UNITED STATES PATENT AND TRADEMARK OFFICE

APPLICATION NO.	FILING DATE	FIRST NAMED INVENTOR	ATTORNEY DOCKET NO.	CONFIRMATION NO.
10/564,226	05/31/2006	Franz Thocmmes	10191/4495	7534

Office Action Summary

DETAILED ACTION

Examines Marked up Figure 4

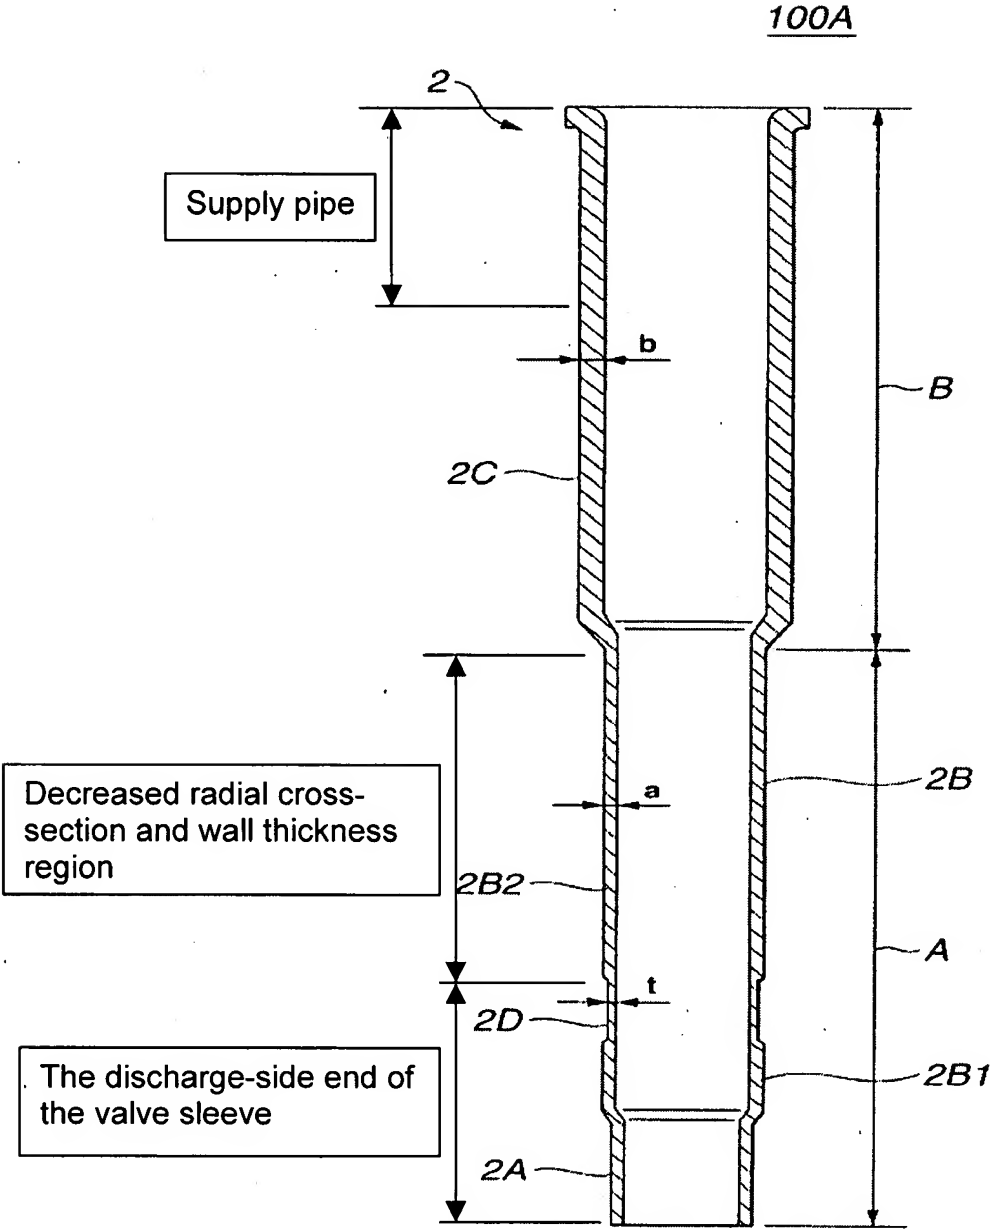
Kobayashi et al shows a fuel injector (1) comprising; a valve needle (7a) an armature (7c) forming an axially movable valve port together with the valve needle, a restoring spring (9) acting upon the armature, a magnetic coil (11) cooperating with the armature, a valve-seat body (5b), a valve closure member (7b) which forms a sealing seat with the valve seat body and; a valve sleeve (2) surrounding the armature and the valve needle, a wall thickness of the valve sleeve varying across its axial direction (fig 4), wherein the wall the wall thickness of the valve sleeve decreases in a discharge

direction of a fuel (figure 4), wherein a radial cross section of the valve sleeve decreases between an inflow-side region and a discharge-side region on a color (figure 4), wherein the radial cross section and the wall thickness of the inflow-side region are constant from the collar to an inflow-side end of the valve sleeve (figure 4); wherein the decreased radial cross section and decreased wall thickness of the discharge-side region are constant from the collar to a discharge-side end of the valve sleeve (see examiners marked up figure of figure 4), and wherein the inflow side region of the valve sleeve is formed in one piece with a supply pipe (see examiners marked up figure 4).

Regarding claim 10, the thickness of the valve sleeve is about .3 to .6 mm in an inflow-side region (paragraph 0038).

Regarding claim 14, the thickness of the valve sleeve is about .2 to .5 mm in a discharge-side region (paragraph 0035).

Secondly, since applicant does not define where "a discharge-side end of the valve sleeve," is located, the examiner is considering the discharge-side end of the valve sleeve to be everything including and below the reduced thickness section 2D of the valve sleeve shown in figure 4. Therefore, the valve sleeve has a constant wall thickness and cross-sectional area from the collar to the discharge-side end of the valve sleeve.
